SDP - Comment Response Letter

Citizen on Constitution  
El Paso County, Colorado

Prepared: October 26th, 2022

**ONSITE CD'S – PCD ENGINEERING  
COMMENT RESPONSE**

STORM SEWER LINE A - PLAN VIEW

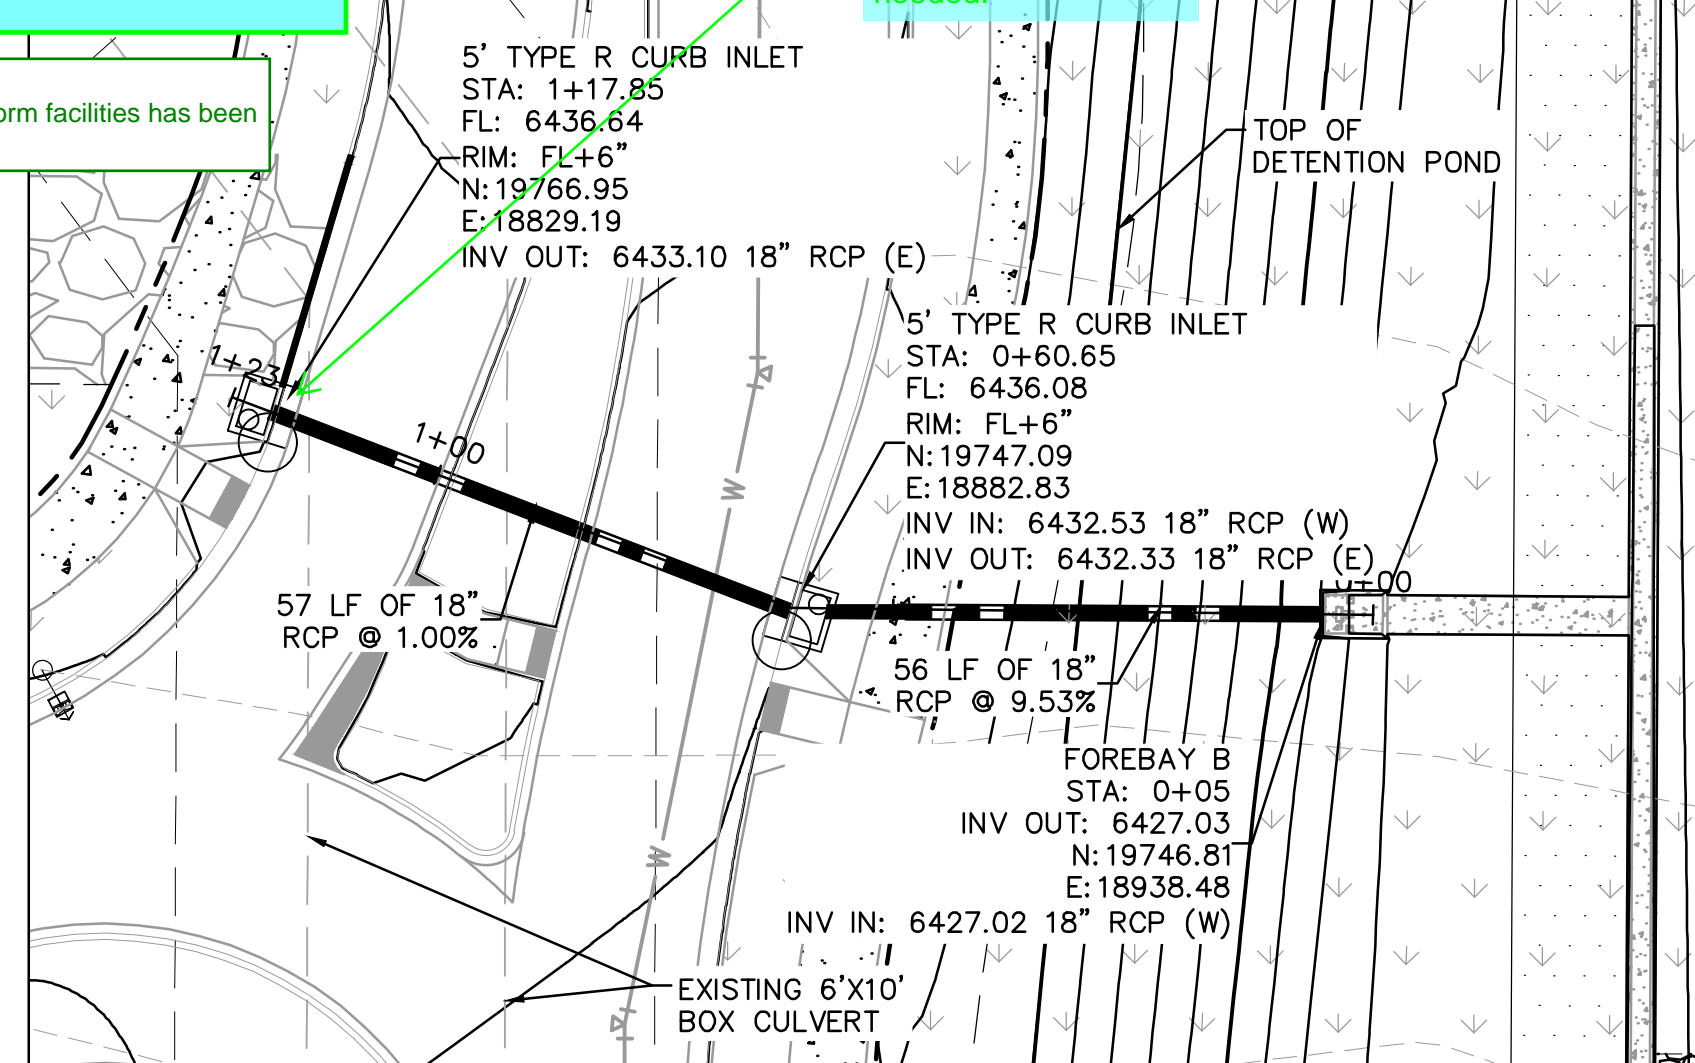
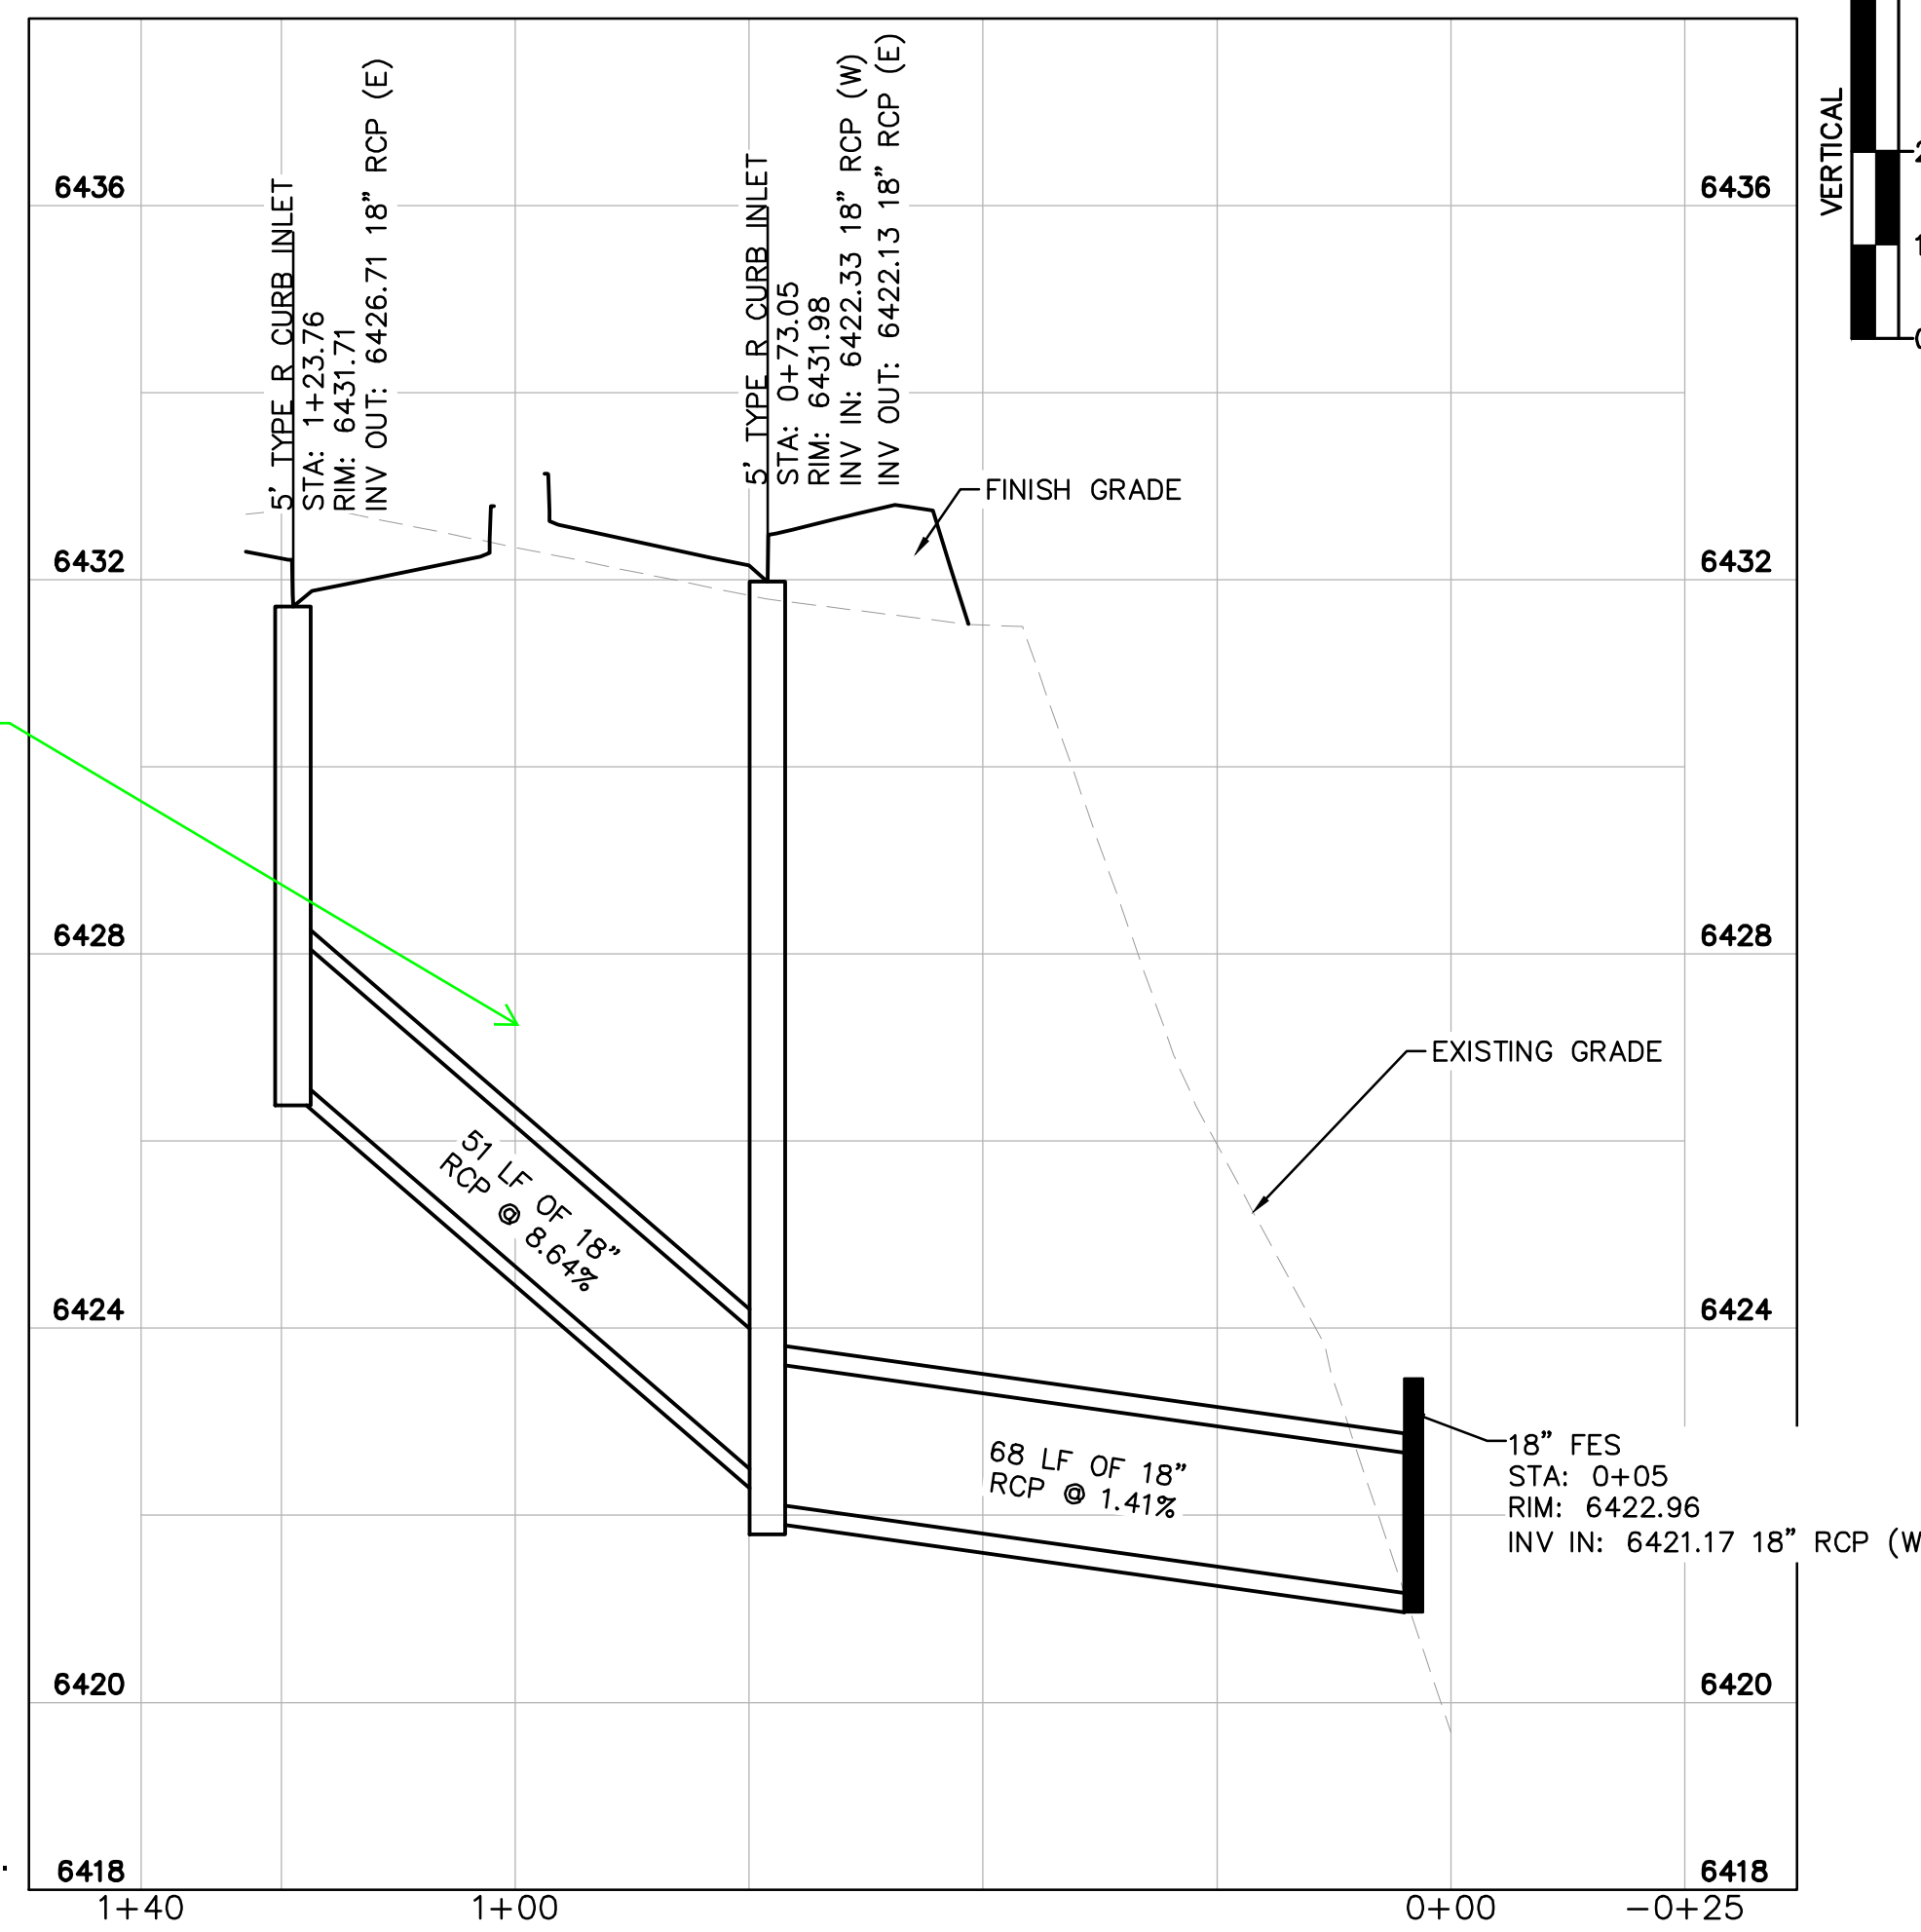
see comment on the Akers CD's and adjust inlet as needed.

KH Response: The inlet locations have remained the same. The flare of the adjacent curb ramp was corrected to be 1.5' per county standard and a 10' transition has been added between the inlet and mountable curb and gutter.

STORM SEWER LINE A - PROFILE VIEW

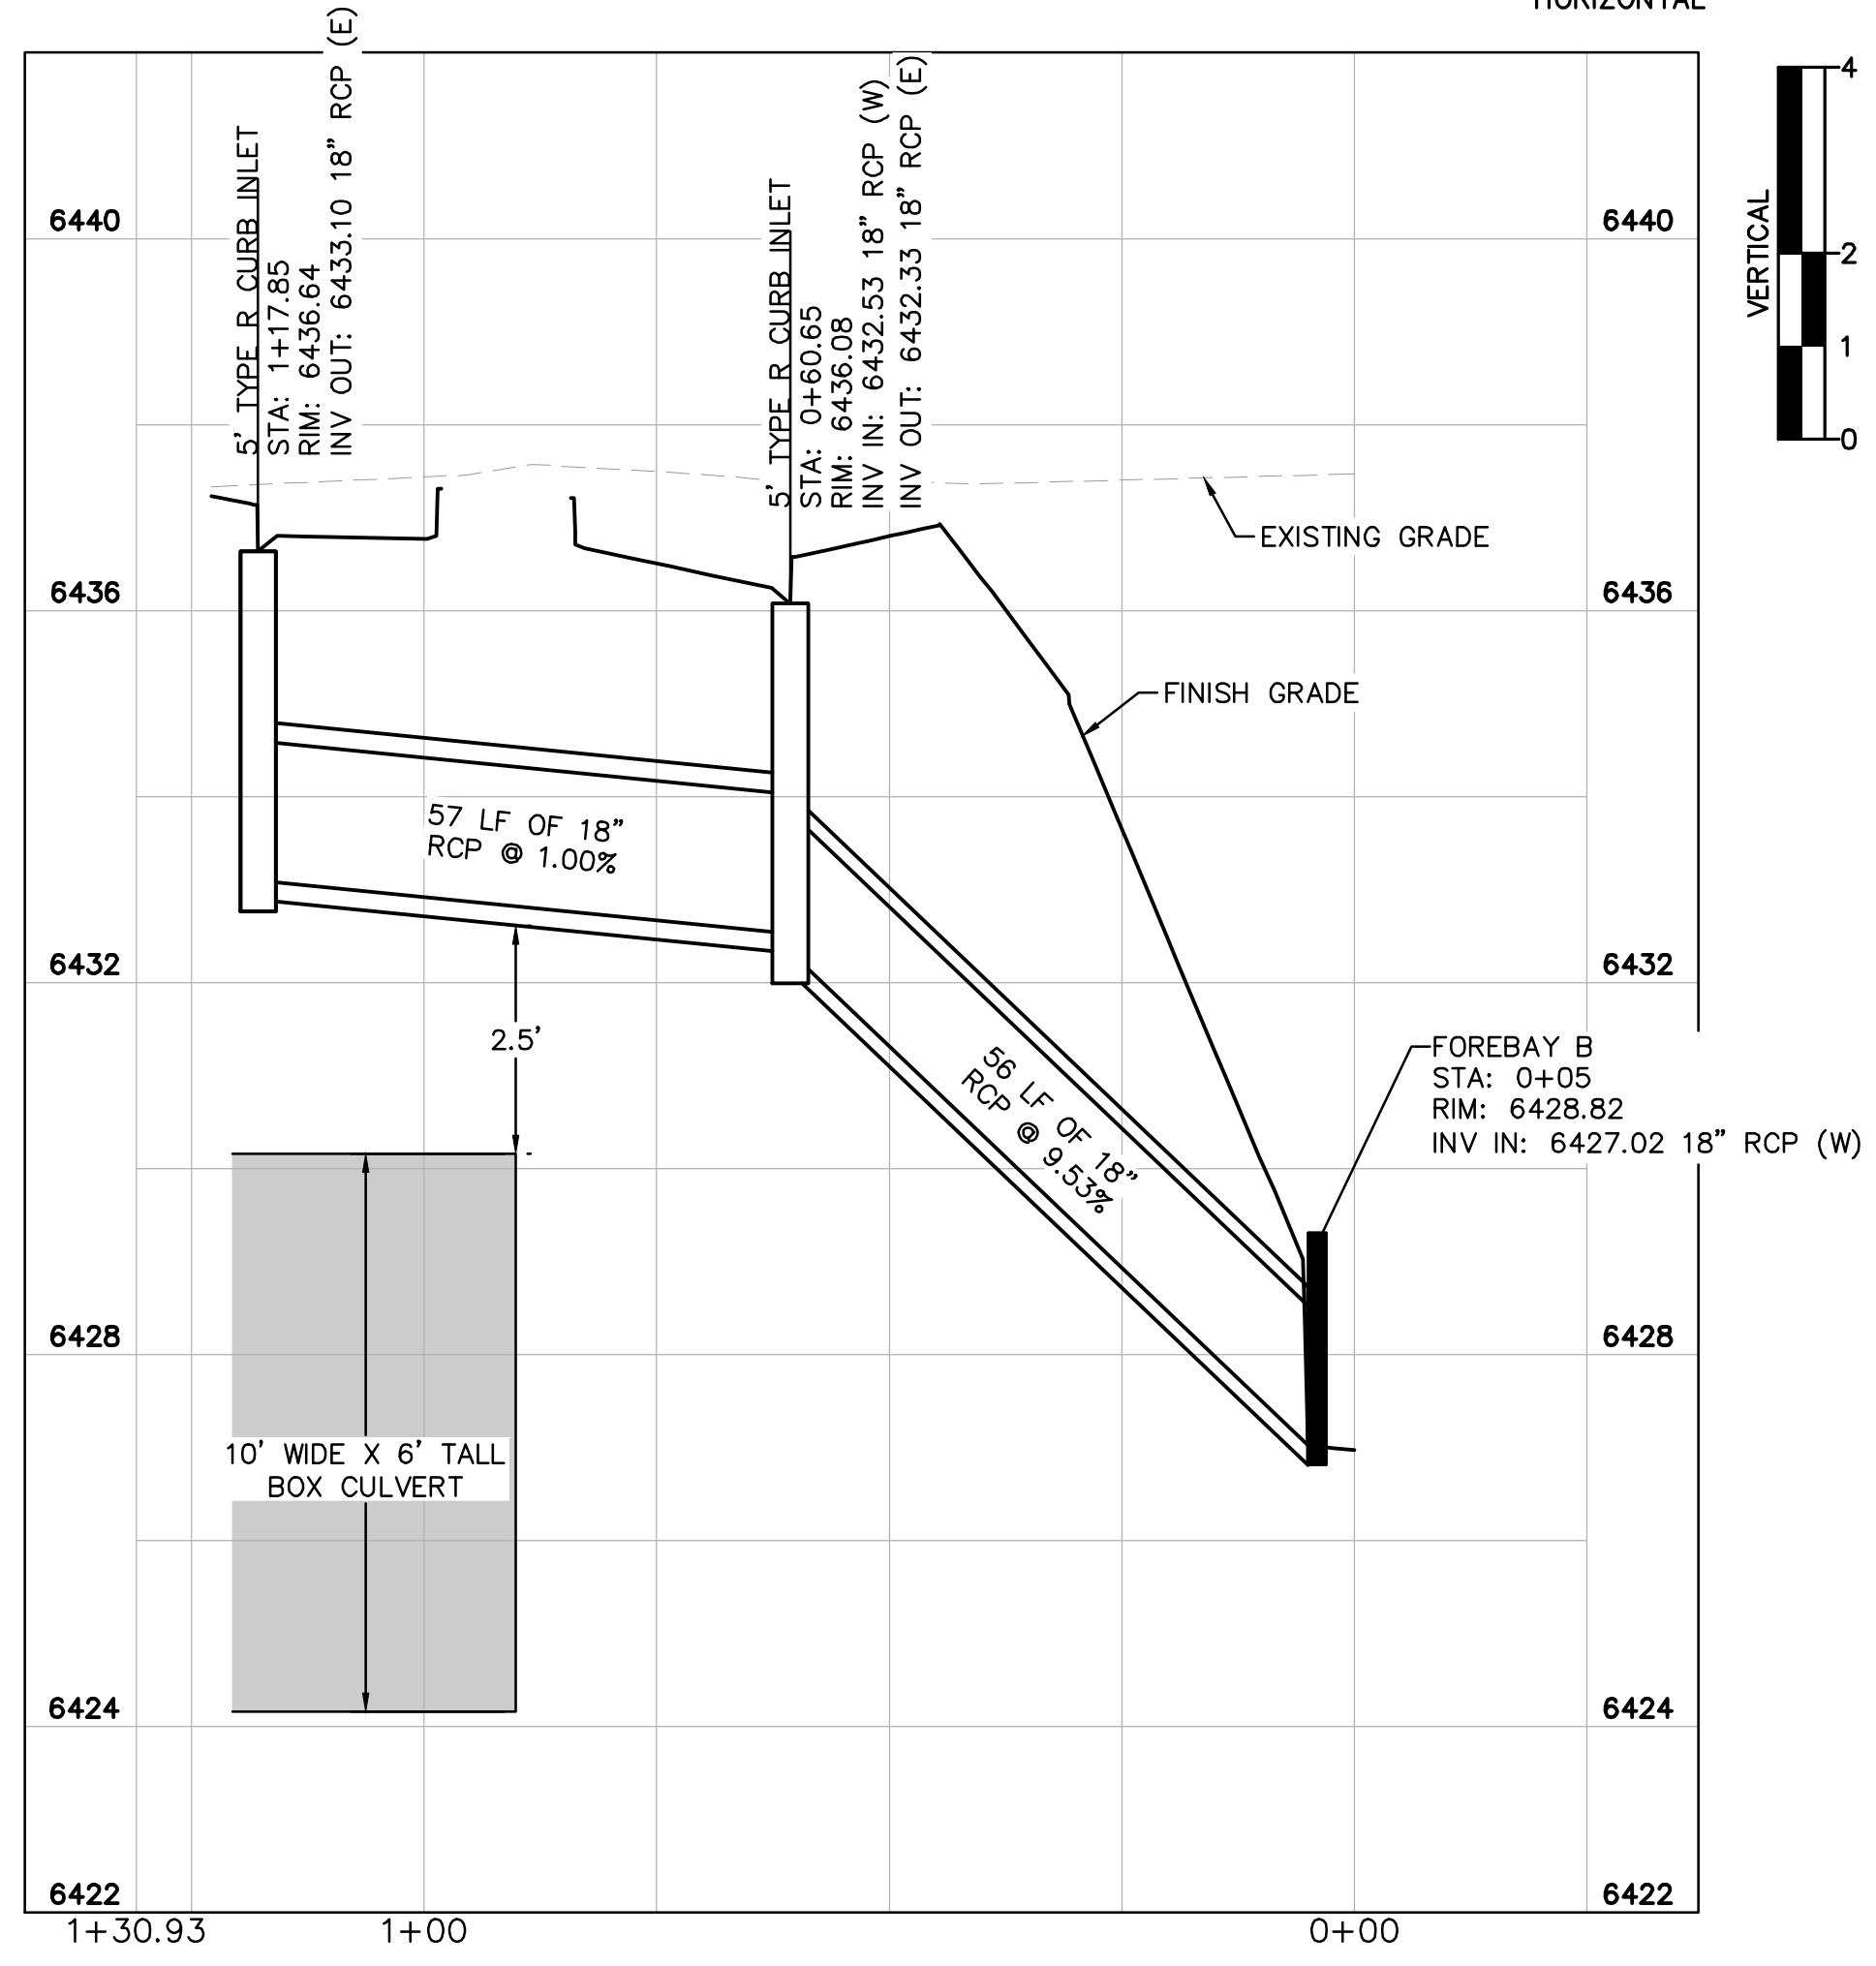
review 1 comment: show 100 year HGL on all storm profiles.
review 2: unresolved
Review 3: storm profiles not provided.
review 4: Please provide the 100 yr HGL on all storm profiles as indicated in the review 1 comment.
KH Response: 100-yr HGL's have been added to each profile.
